NUCLEAR ENERGY INSTITUTE

SUBJECT: Response to NRC Request for Additional Information on Proposed Interim Staff Guidance (ISG)-11: Environmental Assisted Fatigue for Carbon/Low-Alloy Steel

PROJECT NUMBER: 690

**Response to NRC Request for Additional Information
on ISG-11, "Environmental Assisted Fatigue for Carbon/Low-Alloy Steel"**

Figure 1. LAS Uncorrected Data Plotted Against NUREG/CR-6335 Equations and 10% Endurance Limit Standard Variation for Various Quantiles

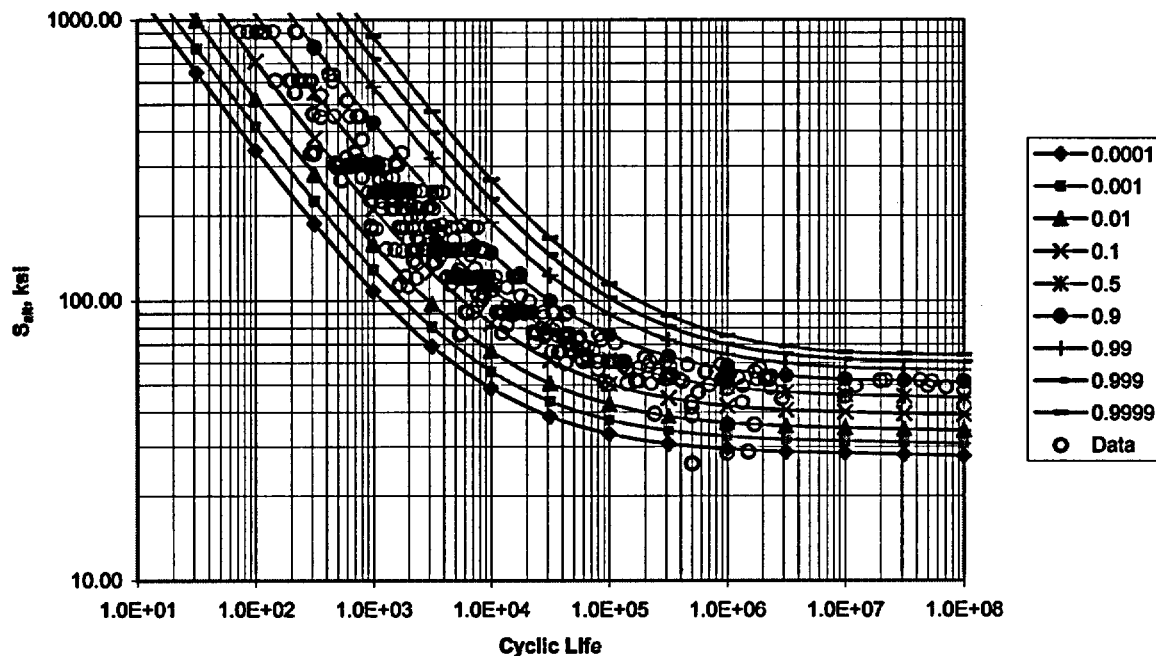
- A. *The revised probabilistic fatigue curves do not appear consistent with the data for carbon and low alloy steels. For example, compare probabilistic curves developed using the EPRI assumption for the standard deviation of the endurance limit with the data presented in Figure 14 of Attachment 1 of the submittal.*

Figure 1 shows the comparison of the ASME low-alloy steel air data from Figure 14 of Attachment 1 of the submittal with Equation 18 of NUREG/CR-6335 and the standard deviation of the endurance limit (10 percent of the endurance threshold) used in MRP-74. Indeed, there are a few points near the endurance limit that are low relative to the EPRI predictions. However, the bulk of the data are above the mean line.

Further study of the data plotted in Figure 1 revealed that the data falling below the curve represented A508 Class 3/Class 4 material with the fatigue testing conducted at an R-ratio (S_{min}/S_{max}) greater than zero, versus the standard test approach using $R = -1$. Since the testing was conducted with a mean stress effect, the apparent stress is higher. Table 1 shows the eight lowest data points as an example.

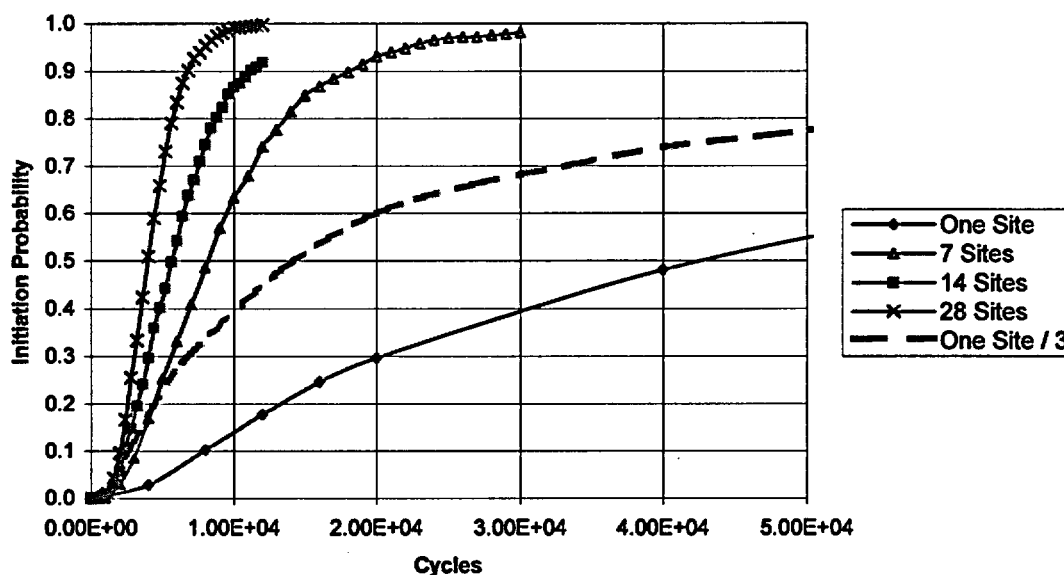
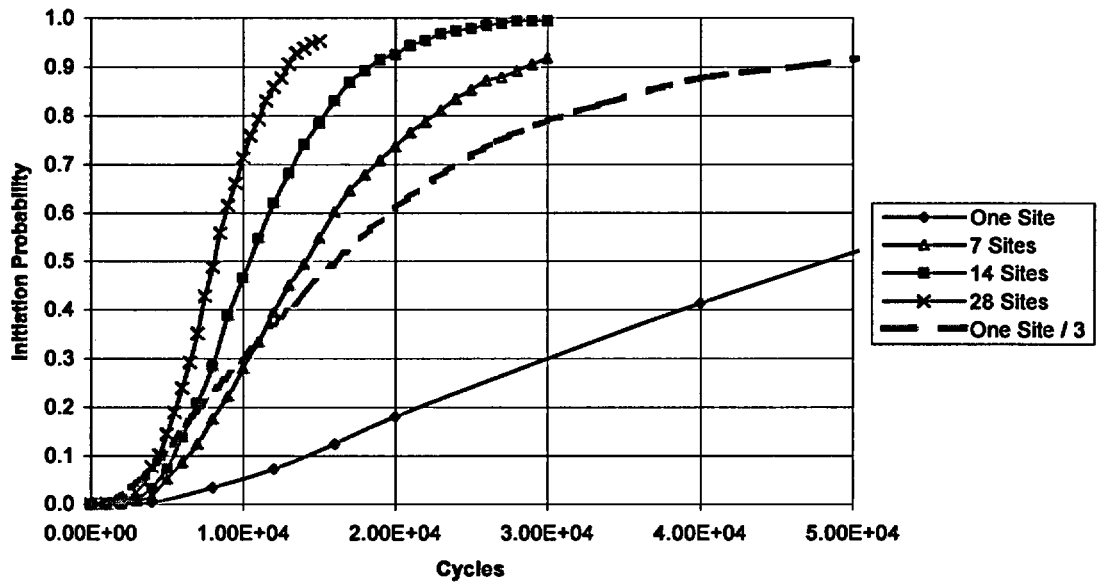
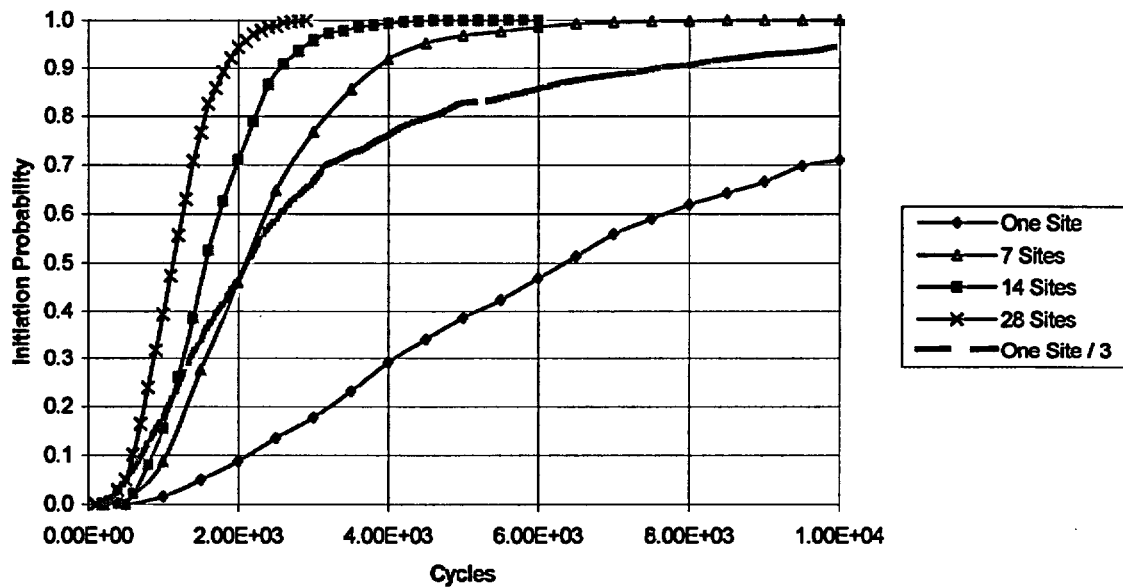
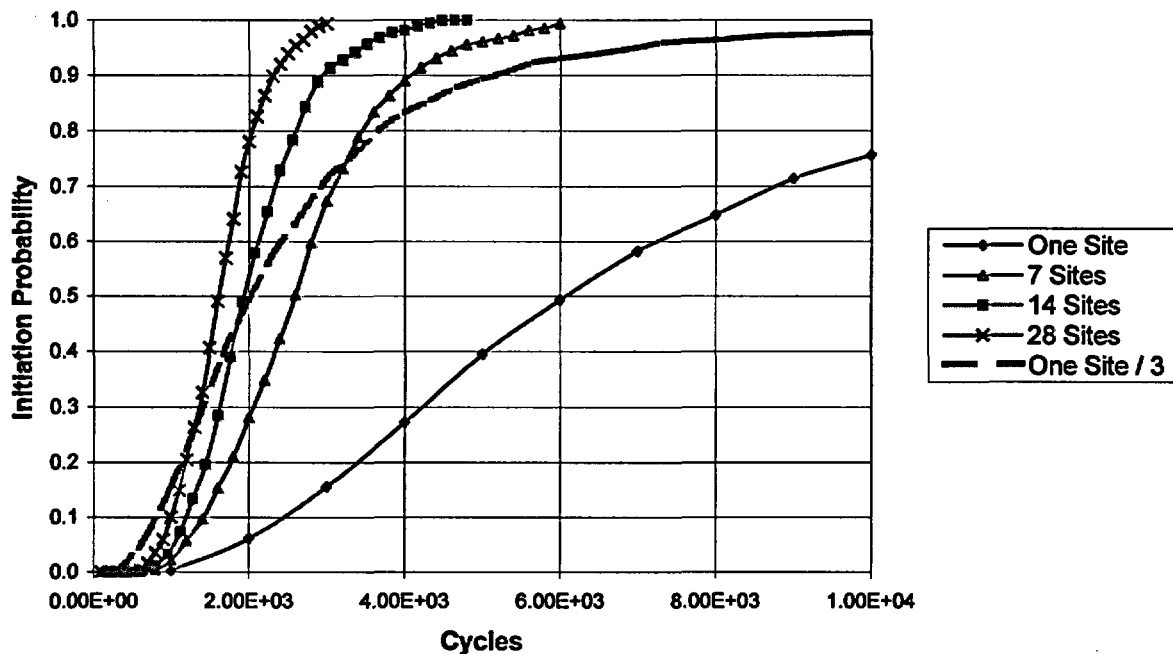
2. *The EPRI report, page 3-3, indicates that the ANL adjustment of $\ln(4)$, used to account for the differences between laboratory specimens and actual components, was included in the study in accordance with the discussion in the PNNL study. Section 4.7 of the PNNL study indicates that the $\ln(4)$ value was adjusted to account for the potential for multiple crack initiation sites. The PNNL study further indicates that the adjustment was calibrated against the data from the 9-inch diameter vessel tests described in the ANL report. Describe how this adjustment was applied in the EPRI study.*

To gain further understanding of this, evaluations were conducted representative of the carbon steel data points in Figure 26 of NUREG/CR-6335. For stress amplitude levels of 45 and 70 ksi, pcPRAISE analyses were run to simulate simultaneous fatigue initiation at 1, 7, 14 and 28 locations. The 14-location run was consistent with the "9-inch" vessel quoted in NUREG/CR-6674. Analysis was conducted for ambient temperature water conditions using the PNNL model used in NUREG/CR-6674 and the model described in Attachment A. In both cases, the model included the factor on the natural logarithm of 4 in the fatigue equations that introduced the factor of 4 for size/geometry and surface finish. Results of this analysis are shown in Figures 11 and 12 for the 45 ksi case and in Figures 13 and 14 for the 70 ksi case.

The results show that the probability of crack initiation increases with the number of loading cycles and with the number of locations around the circumference. The dashed line represents the single location probability with cycles reduced by a factor of three, as was determined to represent a conservative life adjustment factor as described in NUREG/CR-6674.

The first two cases (Figures 11 and 12) represent the lower-strain case in NUREG/CR-6335 Figure 26 for carbon steel. The cycles to the 50 percent probability of crack initiation is about 45,000 for both the PNNL and the Attachment A methodology, consistent with the mean of the two lower data points for the vessel testing. This indicates that the natural logarithm of 4 is an appropriate measure of reduction for size/geometry and surface finish effects for analysis of a single location. For the models with more locations being evaluated simultaneously, the number of cycles to initiation is

under predicted significantly, demonstrating the “double count.” Both figures show that the multi-locations modeling under predicts the probability of initiation except when there is a very low probability of initiation. The 14-location model predicts initiation significantly sooner than the single-model results corrected by the factor of 3 (the dashed line). Since initiation must occur prior to crack growth, the reduction by a factor of three is conservative, especially for components with diameter greater than 9 inches (which represent all of the components in Attachment A).

Results of the second case for higher stress amplitude (Figures 13 and 14) is consistent with the first case and adequately predict the higher stress testing at the 50 percent probability level. Although the method described in Attachment A predicts a slightly higher number of cycles to reach the 50 percent probability level, the reduction factor of three is still conservative. This is especially true since the carbon and low-alloy steel components of the evaluation are all significantly greater than 9-inches diameter.

Thus, the application of the factor of three for life-adjustment in the pcPRAISE analysis is appropriate.

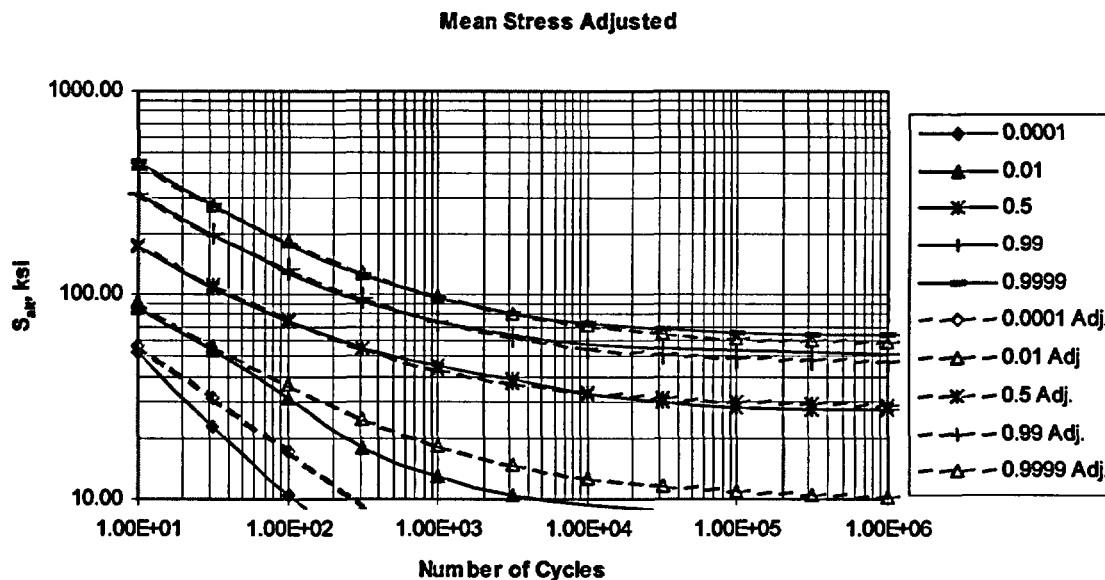
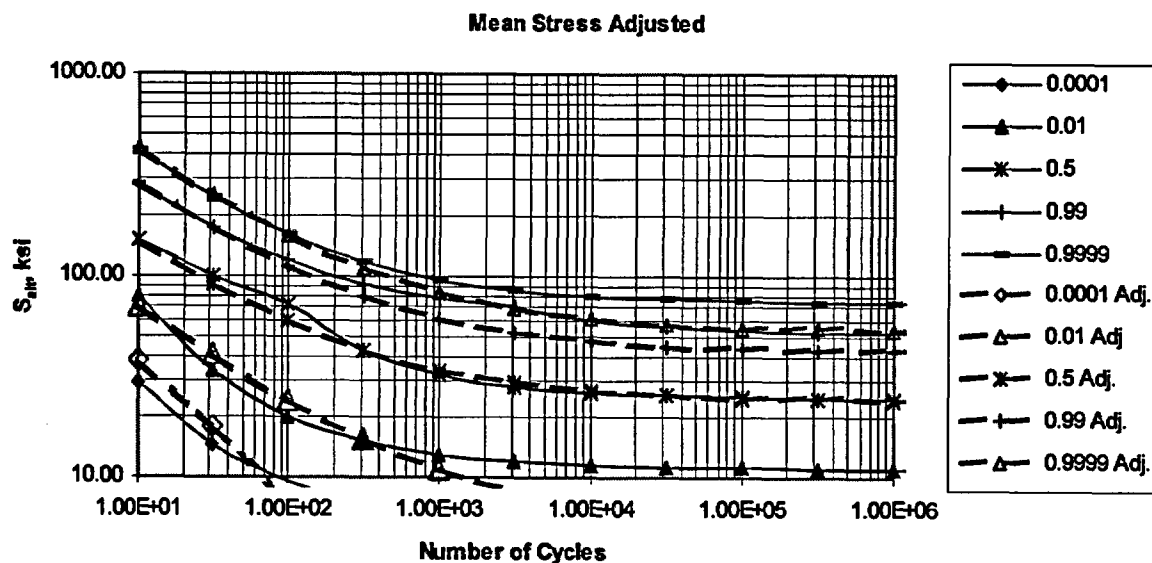
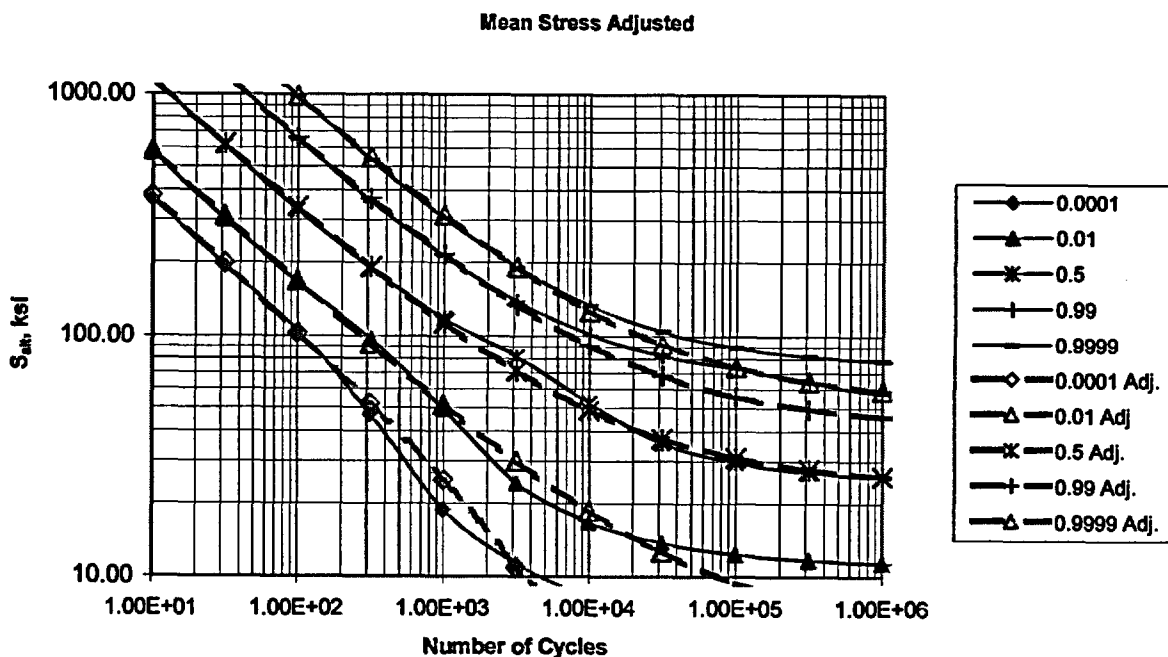
3. *The EPRI report, page 3-11, provides a procedure to account for mean stress effects. Show how this procedure was implemented in the evaluations presented in Chapter 4 of the report. Discuss the consistency of the mean stress adjustment used in the Chapter 4 evaluations with the mean stress adjustment discussed in NUREG/CR-6717.*

Thus, for an applied alternating stress, a corrected stress is used when determining the number of allowable cycles from the fatigue curve. Figures 15 and 16 show the difference between using NUREG/CR-6335 Equation 18 for carbon and low-alloy steels, and for using the NUREG/CR-6335 Equation 5 mean data curves, including the NUREG/CR-6335 coefficients for material variability, with mean stress corrections for $S_y = 40$ ksi and $S_{ult} = 80$ ksi for carbon steel and $S_y = 70$ ksi and $S_{ult} = 100$ ksi for low alloy steel, as were used in deriving the ASME Code curves and Equation 19. There are slight differences since the NUREG/CR-6335 modified fits to include data scatter are not exact fits of the modified Goodman procedure. However, the two are nearly identical, except that the mean stress approach used in MRP-74 is more conservative. Figure 17 shows a similar comparison for low-alloy steel with no environmental effects included.

The one inconsistency in the MRP-74 approach was the assumed value of the yield and ultimate tensile strengths. The values used in NUREG/CR-6335 were the upper bound values derived from the ASME Code basis document ($S_y = 70$ ksi and $S_{ult} = 100$ ksi for low-alloy steel and $S_y = 40$ ksi and $S_{ult} = 80$ ksi for carbon steel. In MRP-74, the standard values from pcPRAISE for determining critical flaw sizes were $S_y = 30.8$ ksi and $S_{ult} = 70$ ksi for low-alloy steel and $S_y = 28.3$ ksi and $S_{ult} = 60$ ksi for carbon steel.
